SINGER PAB 13-8 MOTOR (110-120 v) FOR 400 CLASS MACHINE

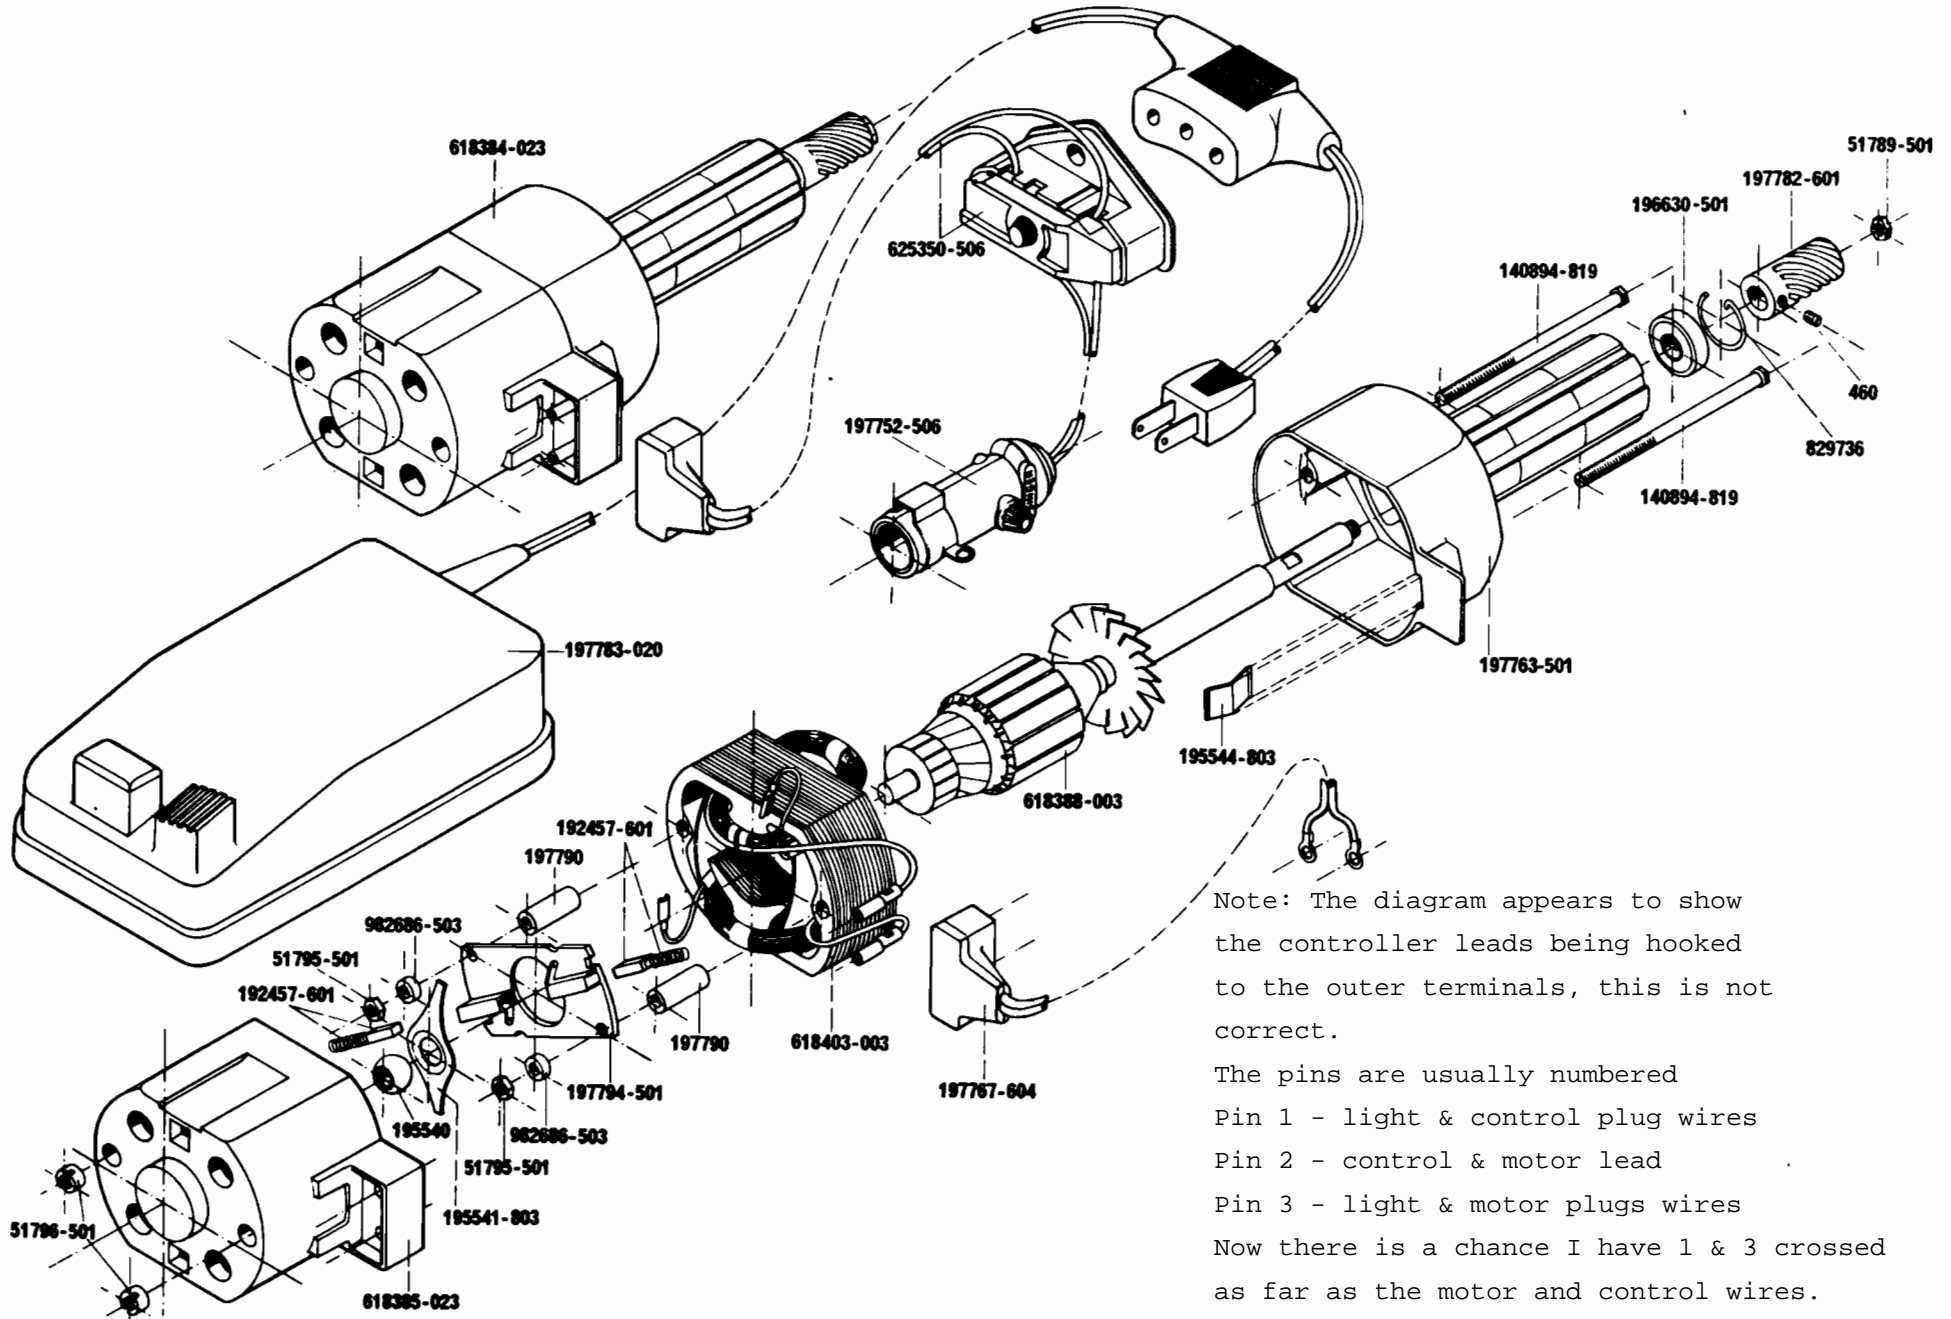
Note: The diagram appears to show the controller leads being hooked to the outer terminals, this is not correct.

The pins are usually numbered
 Pin 1 - light & control plug wires
 Pin 2 - control & motor lead
 Pin 3 - light & motor plugs wires
 Now there is a chance I have 1 & 3 crossed as far as the motor and control wires.
 But will work this way.
